PERMIT #            **PORTLAND - BUILDING PERMIT APPLICATION** DATE 2/12/07 ISSUED  
OCT 27 1987  
1392  
City of Portland

4. Is this a legally recorded lot? yes \_\_\_\_\_ no \_\_\_\_\_  
 II. DESCRIPTION OF WORK: 1392  
to construct a two-story home for year round dwelling, single family as per  
plans  
minor minor site plan review 83A-1-56

**CITY OF PORTLAND, MAINE  
SITE PLAN REVIEW  
Processing Form**

Your application to construct a two story single family dwelling has been reviewed and a permit is herewith issued subject to the following requirement(s):

Plot Plan

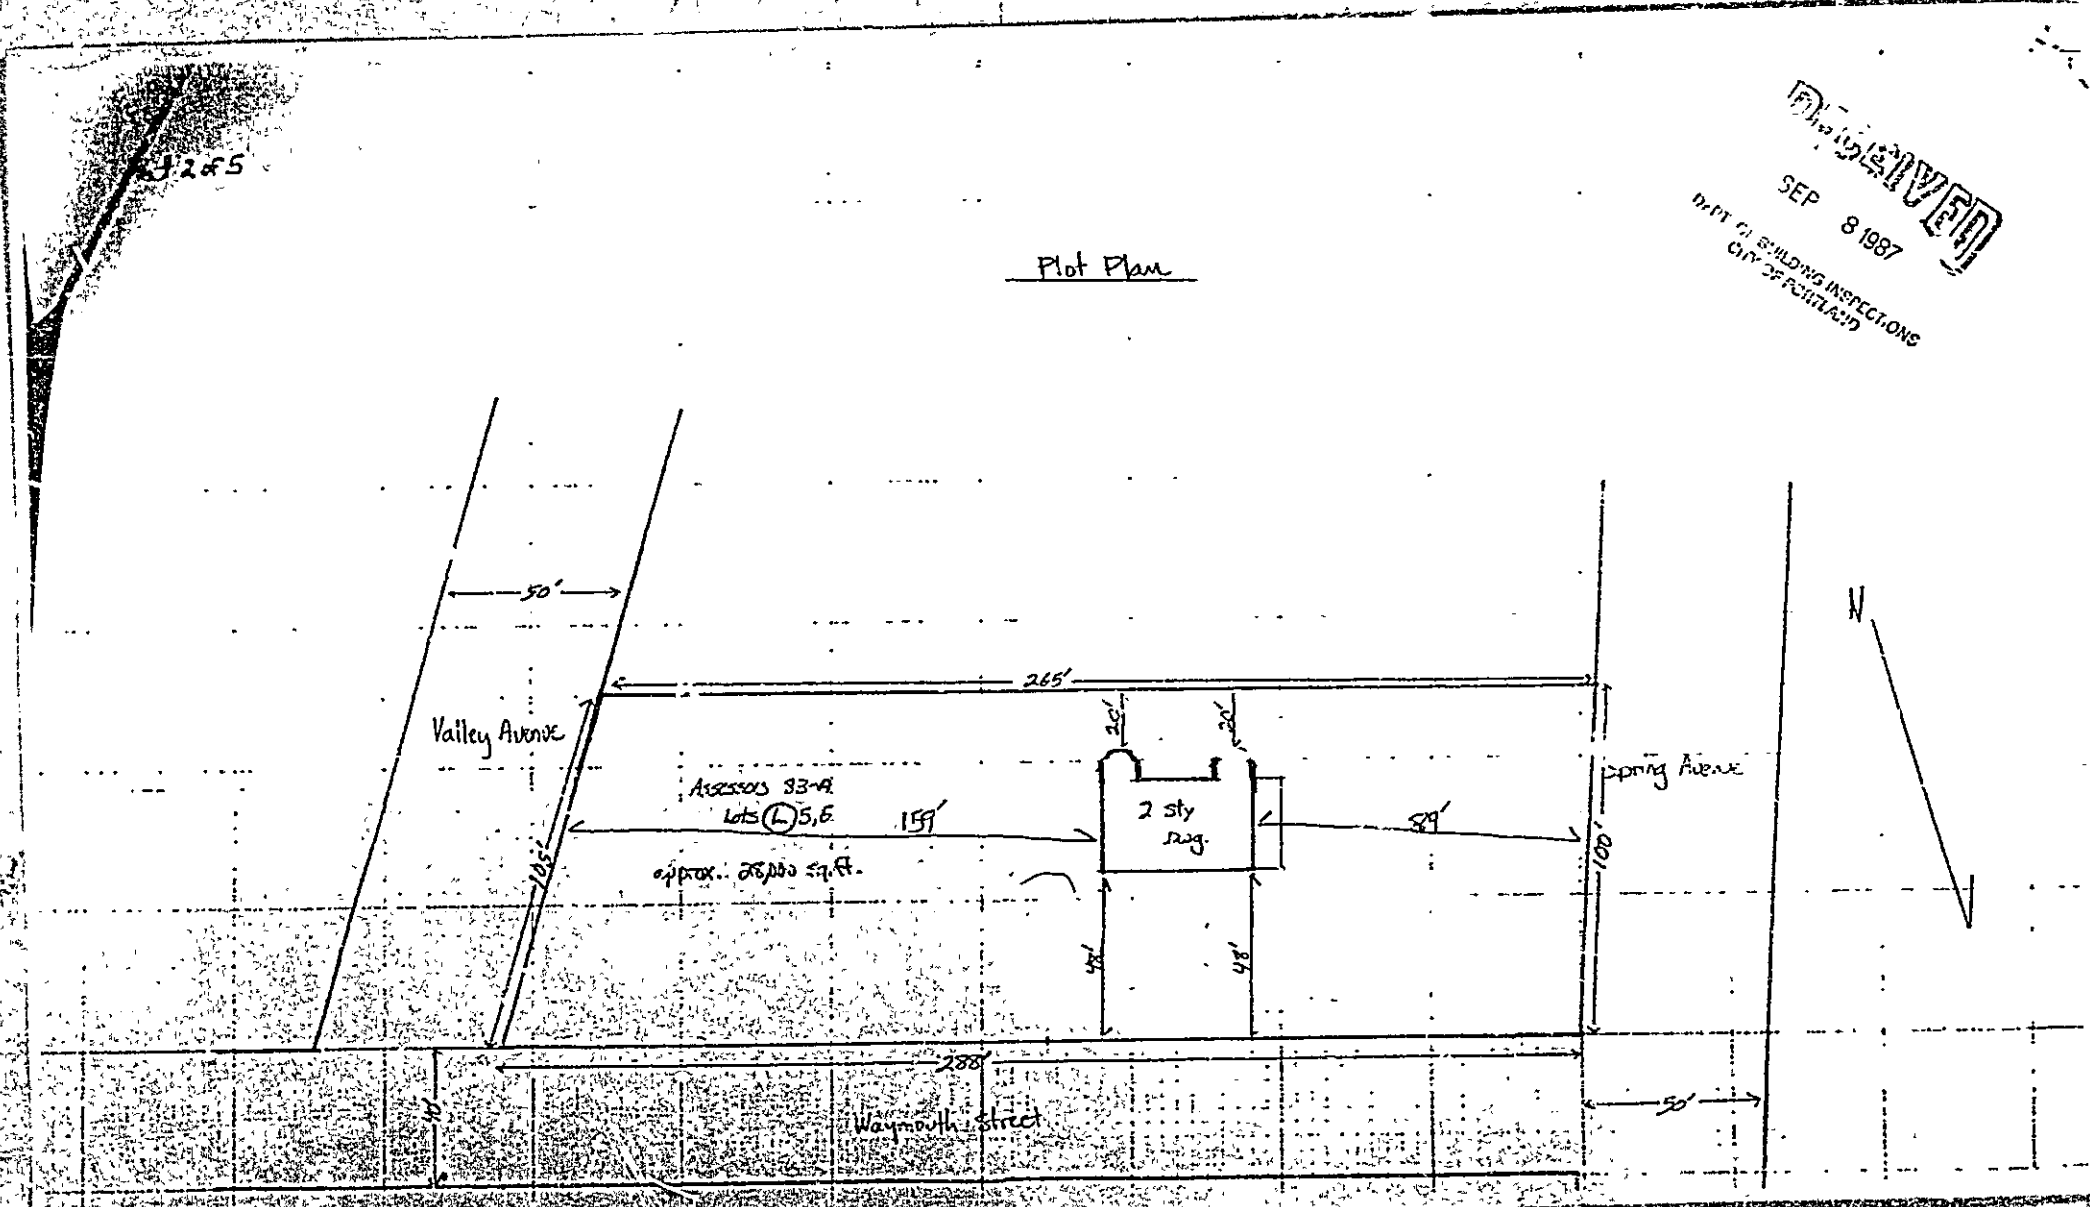
REASONS: Plan does not meet submission requirements of site plan ordinance

Yes	No	Remarks
✓		
	X	
✓		
	X	FFE not shown
	X	
	X	
	X
